# Planning and Zoning Commission

## Wright-Patt Credit Union

### 25-097INF

# 25-097INF - Wright-Patt Credit Union

## Site Features

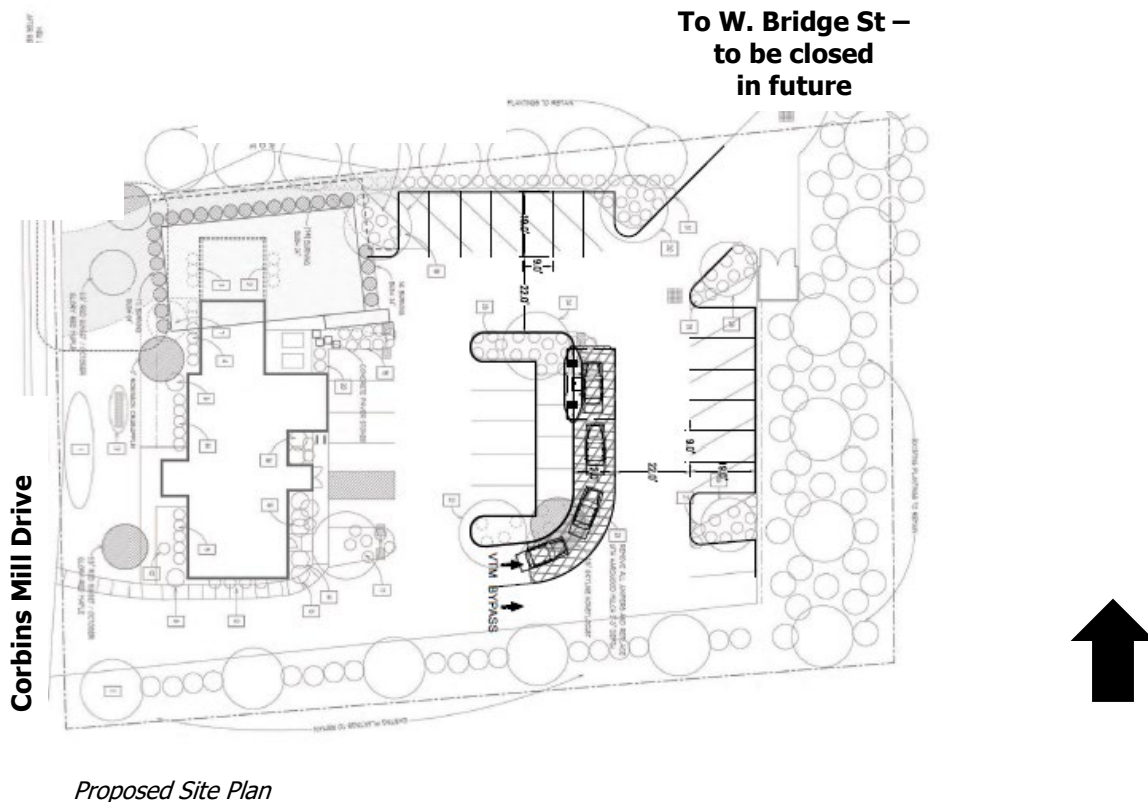
The applicant seeks feedback specifically on the proposed drive-through facility. It is shown located in the center of the site, behind the building, in the middle of the parking area. Four stacking spaces are provided.

Dublin City Code § 153.208 requires eight stacking spaces per bank drive-through: the site plan shows four. If eight spaces were provided, stacked cars would block the rows of the closest parking spaces, monopolizing the site. When the access to W. Bridge Street is removed, this will further exacerbate site circulation.

The proposed central location shows a separate "structure" for the kiosk and any shelter/roof/signage/lighting, rather than a feature integrated into the overall building. This visually emphasizes the auto-oriented nature of the request.

With any proposed changes to drive aisles/circulation, site grading, drainage, and/or stormwater requirements would have to be evaluated and addressed at the next step.
